Memorandum

To: Planning Commission
From: Niall Connolly, Principal Planner
Date: October 16th, 2026
Re: Design Development Review, Parking Lot at MeMe's Cafe, 975 Zion Park Blvd

RAYNER PARKING LOT

SITE/GRADING PLAN & DETAIL SHEET
FOR
RAYNER PARKING LOT
MATT RAYNER
SPRINGDALE, UTAH 84767

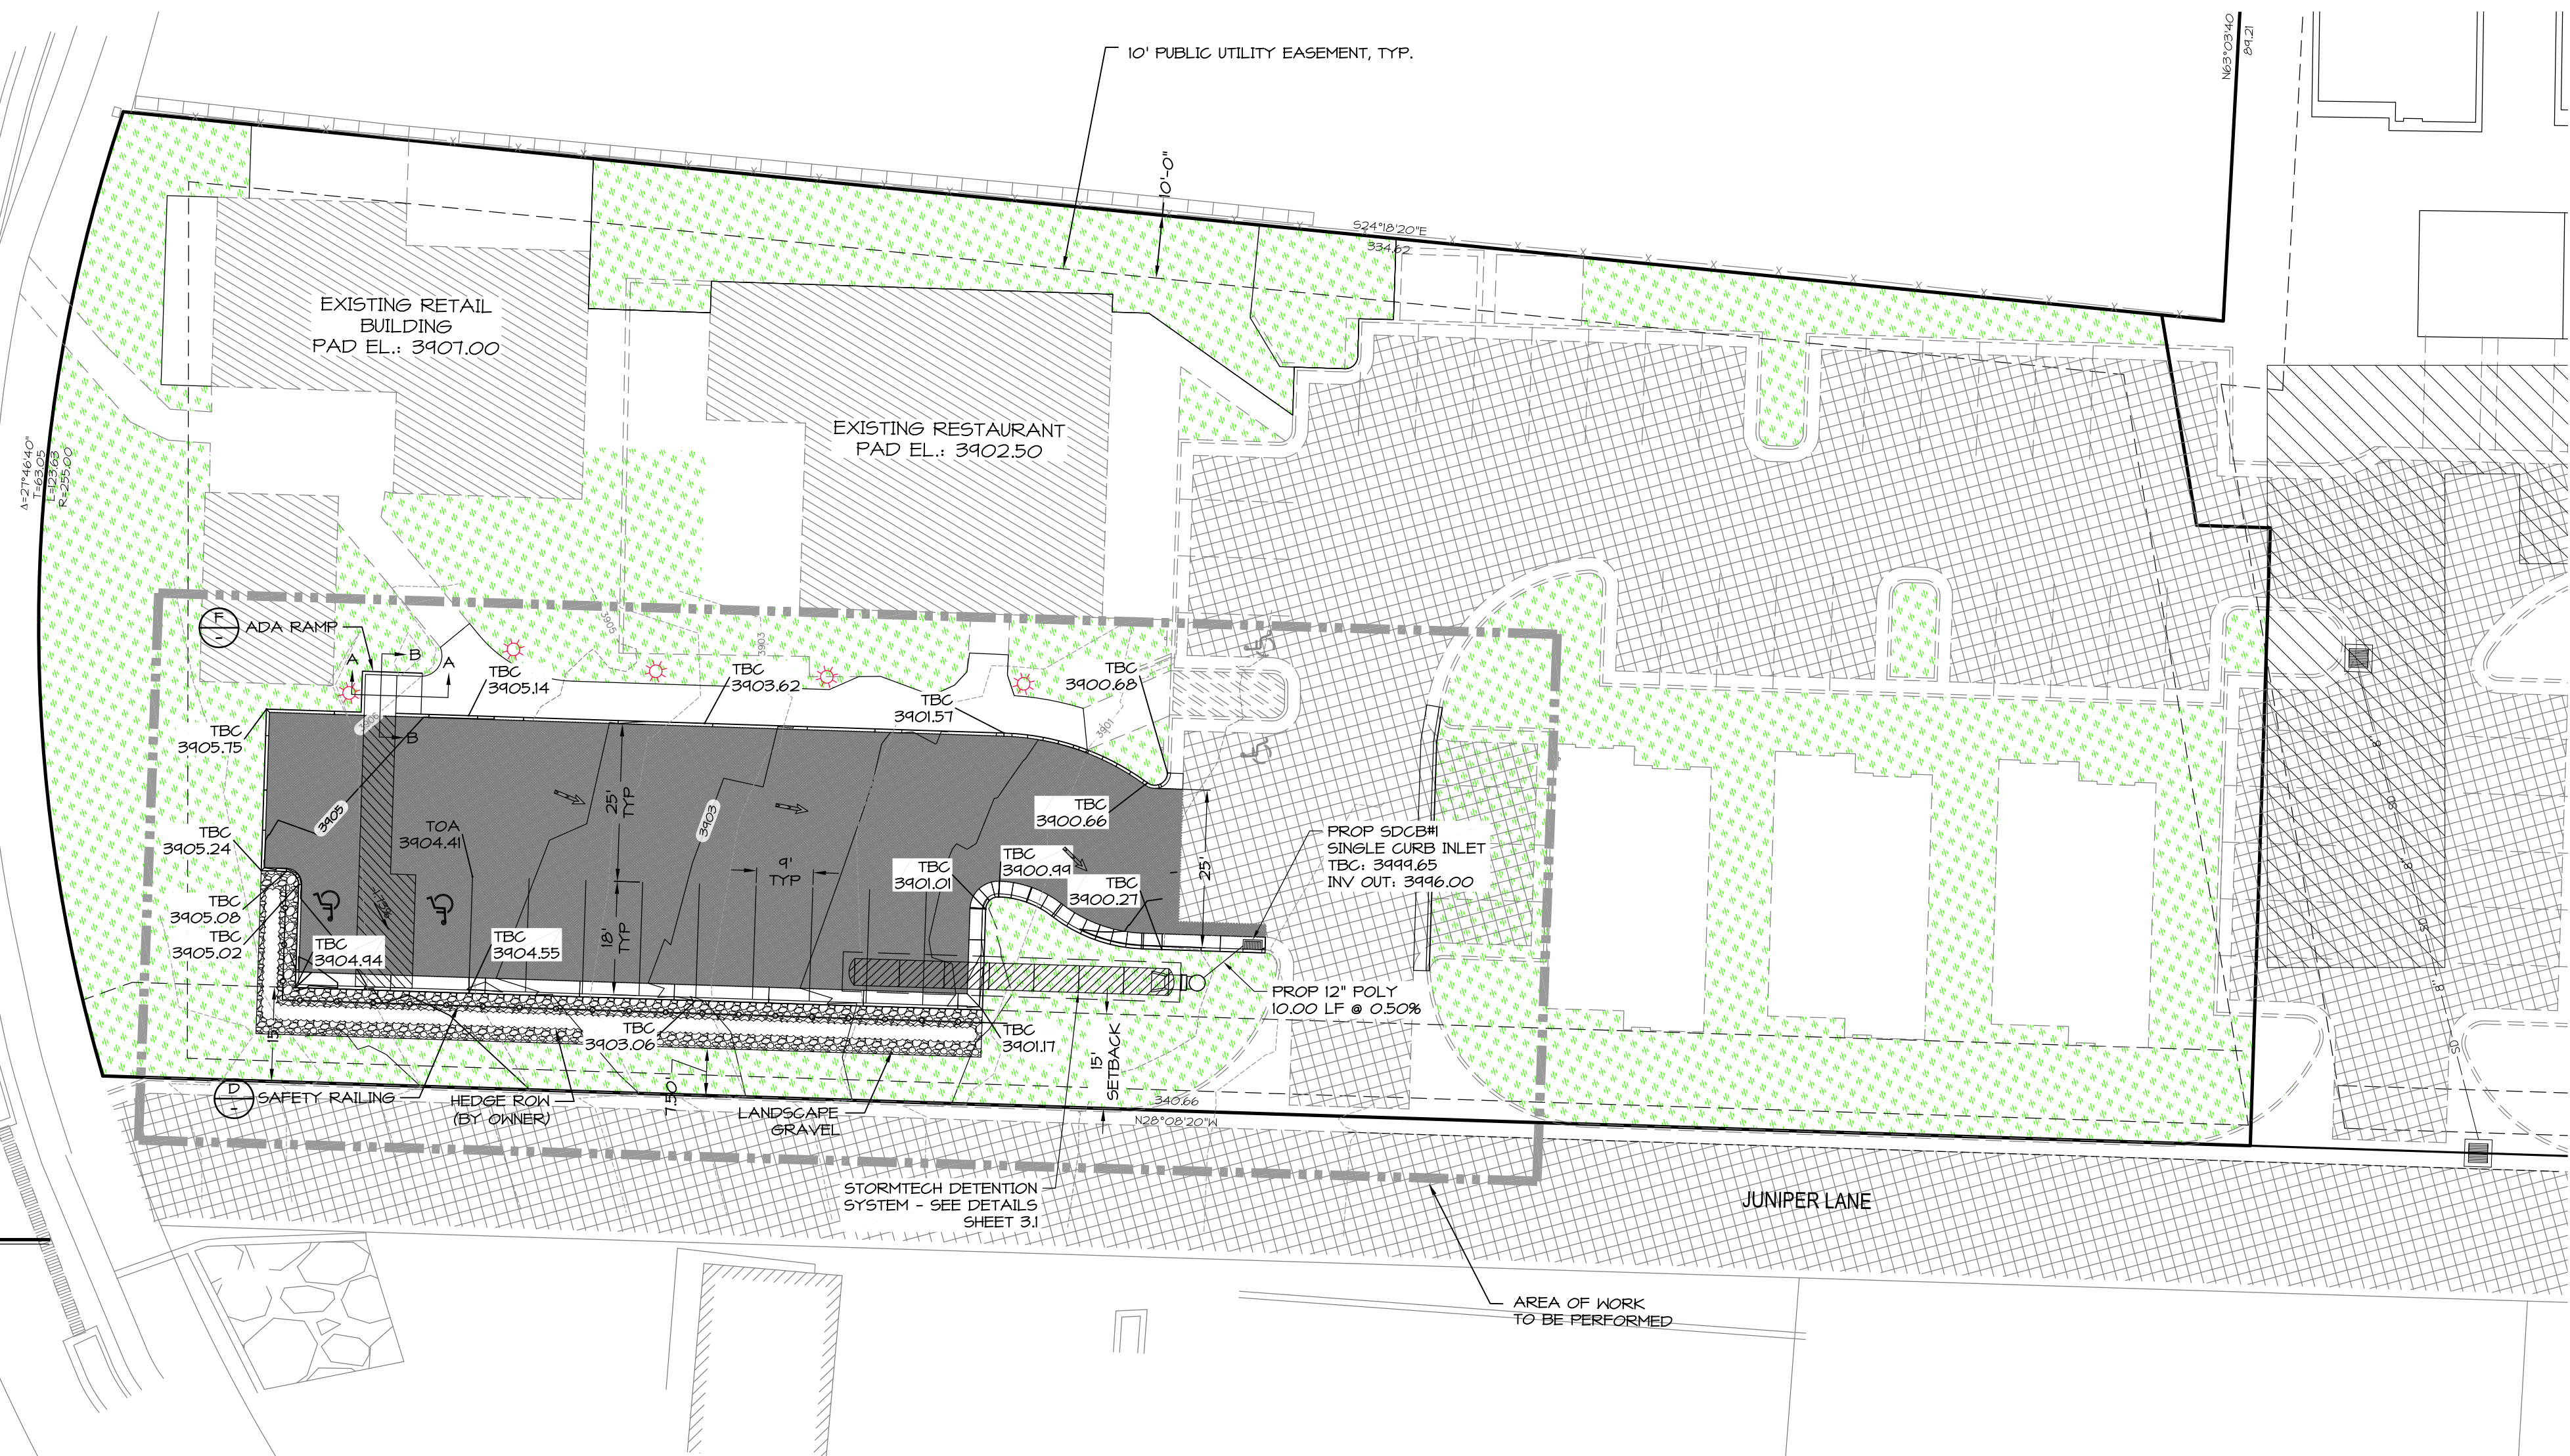
There will be 11 spaces in the proposed parking lot, including two disabled spaces. Seven of the existing parking spaces will be removed and so, post development, there will be a net of four additional parking spaces on the property as a whole. Four of the existing spaces will revert to landscape. (Note - the engineering study says that there would be twelve new spaces, but the plans show eleven. In the original

design, there were twelve standard spaces, but the design was amended to create nine standard spaces, with two ADA spaces. The overall footprint has not changed, and therefore the conclusions of the engineering study are not affected.)

<i>Pedestrian Amenities</i>	Section 10-11A-14B (3) requires central commercial zone properties to have at least one exterior amenity for the convenience of pedestrians or cyclists.	The plans don't show a pedestrian amenity.	The planning commission should request a condition requiring a pedestrian amenity at the front of the property.
<i>Grading</i>	Slopes of 30% or greater must not be disturbed. Retaining walls must be no taller than 10 ft.	The site is relatively flat, but gradually slopes downwards away from SR-9. The site grading plan shows some very minor	Complies.

re-grading, which will be necessary to create the parking lot and for drainage. There will be curbs, but no retaining walls.	
--	--	--	--

1. The safety railing must be treated to be non-reflective and must be a color that complies with the Town Color Palette.
2. In the absence of a consistent landscape plan, the approved area of landscape is as shown on the cover sheet (1.0) drawing prepared by Rosenberg Associates. A certificate of final inspection

will not be issued until all required areas have been converted to landscape, as shown in this drawing.
